CULPS BODY SHOP
 WESTINGHOUSE BLVD., CHARLOTTE, NC

SITE PLAN

C1.0

SUBJECT: Administrative Approval for Petition No. 2001-31, Adam Culp.

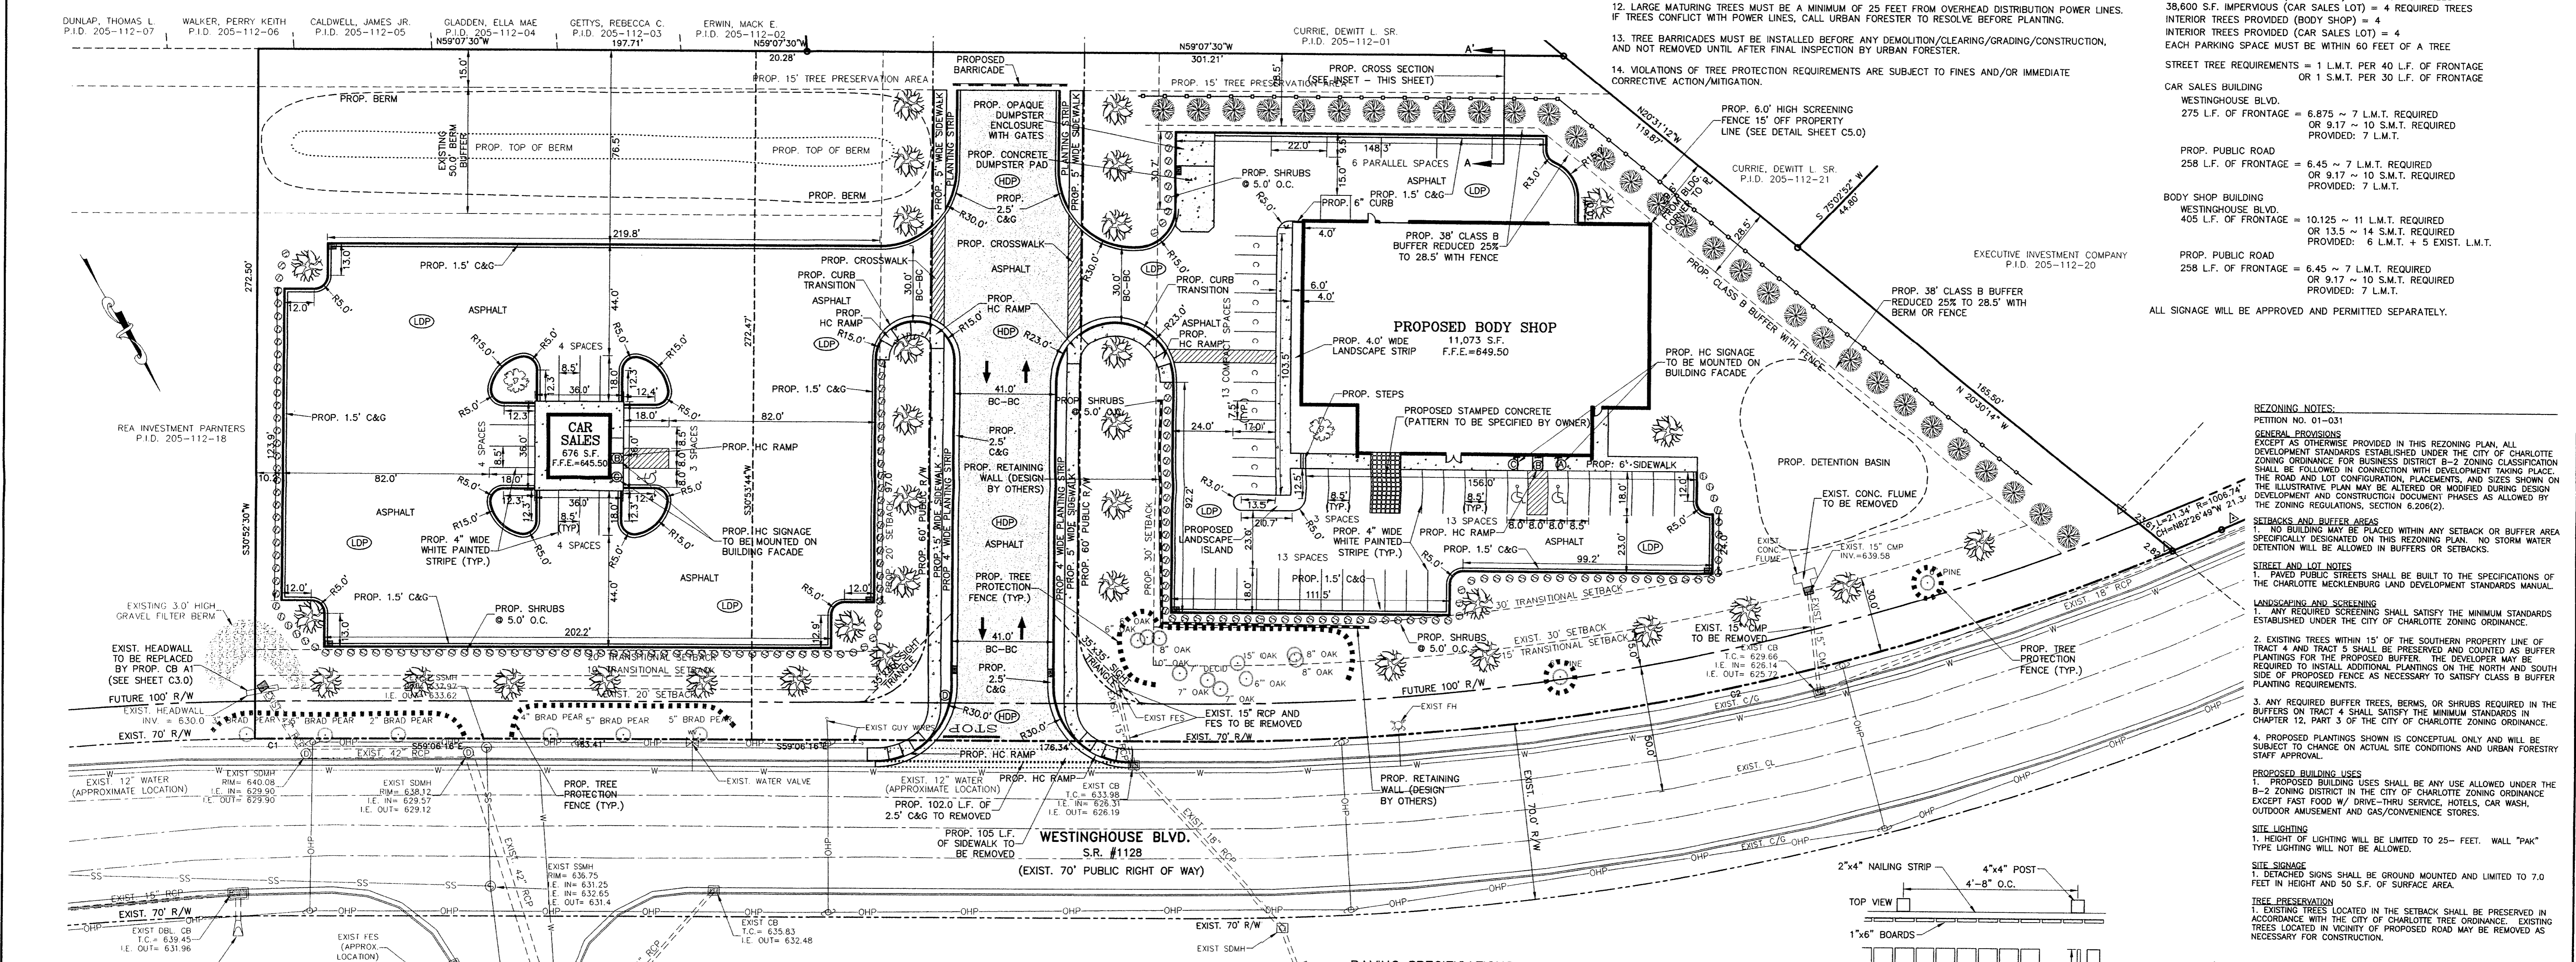
Attached is a revised site plan for the above petition. The plan has been revised to reflect a change in the design of the public street to be constructed across the property. Since this change is minor, I am administratively approving this revised plan. Please use this revised plan when evaluating requests for building permits and certificates of occupancy.
